TO: Mercedes-Benz and Freightliner Dealer Principals, General Managers, Sales Managers, Service Managers, Parts Managers	FROM: Anthony Washington, Department Manager, Regulations and Certifications
RE: <b>Launch Recall Campaign Notification</b> <b>Model 907 (Sprinter)</b> <b>Model Years 2019</b> <b>Replace Rear-side Windows</b>	DATE: November, 2019

<b>Campaign No. :</b>	<b>Campaign Desc. :</b>	<h2>Replace Rear-side Windows</h2>
<b>2019100008</b>	<b>VS3VERGLAS</b>	
<p>This is to notify you of the upcoming <b>Recall Campaign</b> to replace the rear-side windows on approximately <b>876</b> MY19 Sprinter vehicles. The recall campaign will be visible on the <a href="http://www.safercar.gov">www.safercar.gov</a> website and may generate questions from customers. All affected VINs will be flagged as “<b>Open</b>” in VMI.</p>		
<b>Background</b>		
<b>Issue</b>	<p>Mercedes-Benz AG (“MBAG”), the manufacturer of Mercedes-Benz and Freightliner vans, has determined that, due to a documentation error, certain Sprinter vehicles (VS30; Platform 907) which should have been manufactured with rear side windows in laminated safety glass, were incorrectly manufactured with single-pane safety glass on

D67.30-A001-79

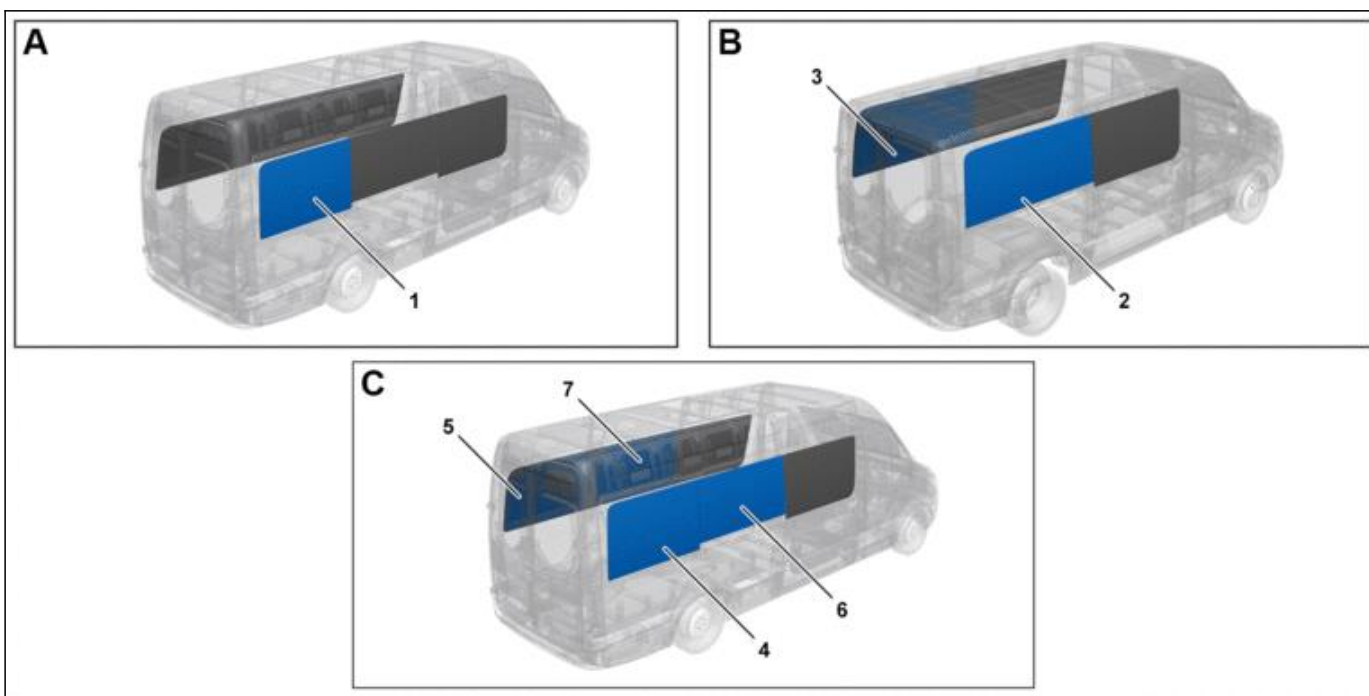
2.1	Replace rear right side window (1).	<p>Model 907.745 1P as of 021618 up to 100312 with code F43 (Side windows in rear laminated glass)</p> <p>Model 907.745 1T as of 000156 up to 005399 with code F43 (Side windows in rear laminated glass)</p> <p><b>i</b></p> <p>See picture A</p> <p><b>i</b></p> <p>Dispose of removed side window (1) properly. Observe the applicable legal requirements and specifications of the relevant country.</p>	AR67.30-D-2400TS

2.2	Replace side windows (2, 3) at rear left and right.	<p>Model 907.643 1P as of 049635 up to 124633 with code F43 (Side windows in rear laminated glass)</p> <p><b>i</b></p> <p>See picture B</p> <p><b>i</b></p> <p>Dispose of removed side windows (2, 3) properly. Observe the applicable legal requirements and specifications of the relevant country.</p>	AR67.30-D-2400TS

2.3	Replace left center, right center, rear left and rear right side windows (4, 5, 6, 7).	<p>Model 907.645 1P as of 058365 up to 107867 with code F43 (Side windows in rear laminated glass)</p> <p>Model 907.647 1P as of 103982 up to 120724 with code F43 (Side windows in rear laminated glass)</p> <p>Model 907.655 1P as of 054351 up to 124991 with code F43 (Side windows in rear laminated glass)</p> <p>Model 907.657 1P as of 073138 up to 125930 with code F43 (Side windows in rear laminated glass)</p> <p><b>i</b> See picture C</p> <p><b>i</b> Dispose of removed side windows (4, 5, 6, 7) properly. Observe the applicable legal requirements and specifications of the relevant country.</p>	AR67.30-D-2400TS
-----	--	--	------------------
